Subject: Stem-Wedge Separation of an Anchor/Darling Double Disc Gate Valve at Exelon, LaSalle County Station, Unit 2, February 2017.

Reference: Flowserve, Raleigh 10CFR Part 21 Notification Letter dated February 25, 2013, Wedge Pin Failure of Anchor/Darling DD Gate Valve.

This is to notify the US Nuclear Regulatory Commission that, in accordance with the provisions of 10CFR Part 21, we have gained additional insight and information concerning the referenced previously reported issue based on a recent incident at the LaSalle County Station, Unit 2 involving a similar valve.

Figure 1
Typical Double-Disc Gate Valve Trim

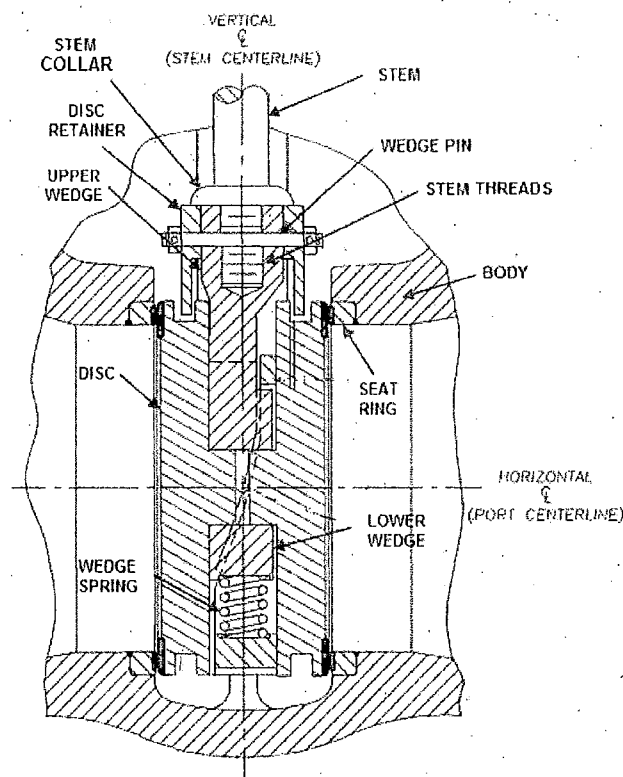
Flowserve has been working with Exelon and nuclear industry groups to investigate and evaluate the stem-wedge separation in a size 12 class 900 Anchor/Darling motor-operated double disc (DD) gate valve. The valve stem was completely separated from the upper wedge, the wedge pin was sheared, the wedge threads stripped away and the pressed-on stem collar was pushed up leaving the valve inoperable. The valve operating thrust and torque is transmitted through the stem-wedge assembly, therefore separation of the stem and wedge will prevent the valve from opening and can adversely affect closing. See Figure 1 for a sketch of the stem-wedge joint.

Review of the LaSalle incident concluded repeated valve cycles at high actuator loads eventually wore the wedge threads to the point of failure in shear during a valve closing cycle and subsequent separation of the stem from the wedge. Before thread failure the wedge pin sheared which allowed stem to wedge movement with accompanying wedge thread wear and degradation. In addition the pressed-on collar was pushed up out of position, which would reduce or eliminate any existing preload in the joint. Wedge pin failure is attributed to both limited preload on the stem threaded section and exposure to actuator torques higher than the limit of the pin material. Since stem-wedge preload can be reduced or removed by a stem thrust which exceeds the stem-wedge joint capability, high thrust can be a precursor for wedge pin shear for applications with wedge pins that cannot independently withstand the actuator stem torque. The capability to maintain the preload is much less for stems with pressed-on collars than for stems with integral collars.

A loose connection is the result of inadequate stem thread preload whether not applied initially during assembly or not maintained during operation. The initial stem preload can be reduced if the stem closing thrust in service is high enough to cause local yielding of the joint. Stems with integral collars typically have allowable thrusts which do not govern the thrust limit of the valve however a stem with a pressed-on collar, supplied with many of the originally supplied valves, has a thrust limit which is less than the typical maximum allowed thrust values previously determined by weak-link or maximum thrust analyses.

- Torque the stem into the wedge to the maximum joint capacity.
- Replacement stems should have integral collars in lieu of press-on.
- Replacement wedge pins are manufactured from high strength material.
- Verify the actuator stem thrust is less than the maximum allowed to maintain the stem preload.
